PROPOSED WATERSHED MAP
CENTER & MAIN
1440 MAIN STREET, CONCORD, MA

6	
5	
4	REDLINE NOV. 12, 2019 - SUBCATCHMENTS TO EDIT 34-UNIT PRD
3	REVISED OCTOBER 18, 2019
2	REVISED JULY 11, 2019
1

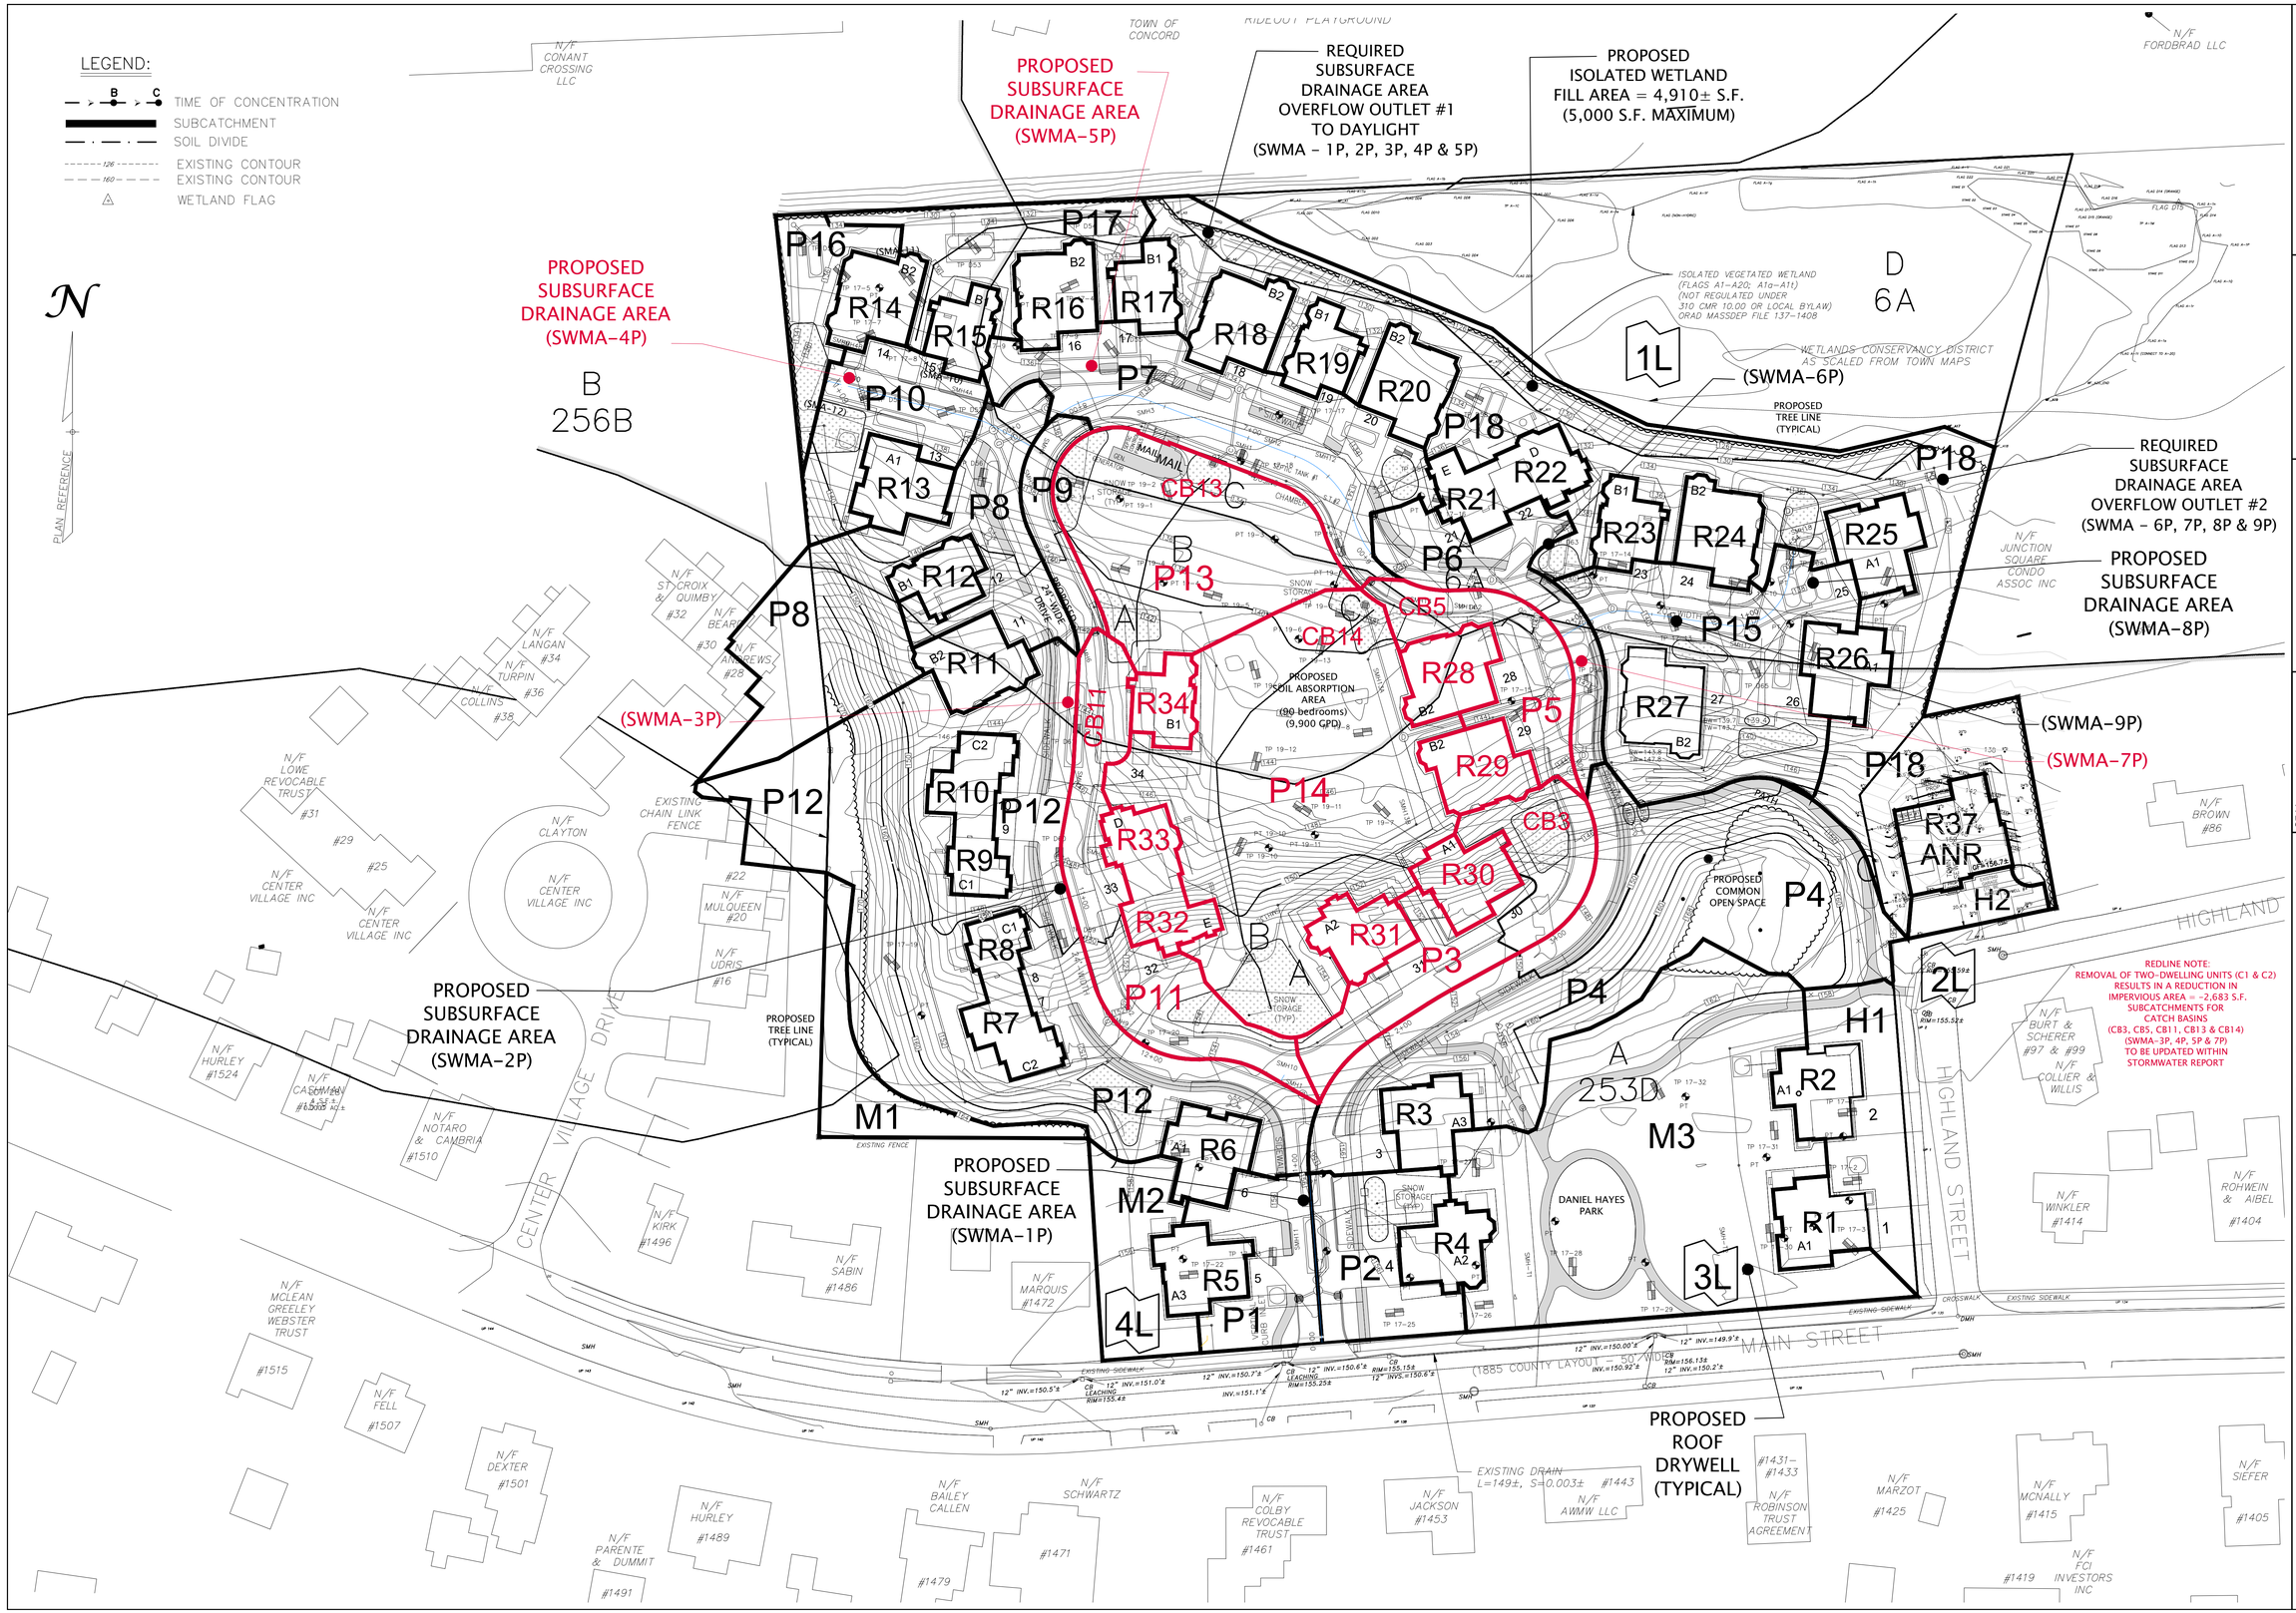
REDLINE NOTE:
REMOVAL OF TWO-DWELLING UNITS (C1 & C2) RESULTS IN A REDUCTION IN IMPERVIOUS AREA = -2,683 S.F. SUBCATCHMENTS FOR CATCH BASINS (CB3, CB5, CB11, CB13 & CB14) (SWMA-3P, 4P, 5P & 7P) TO BE UPDATED WITHIN STORMWATER REPORT
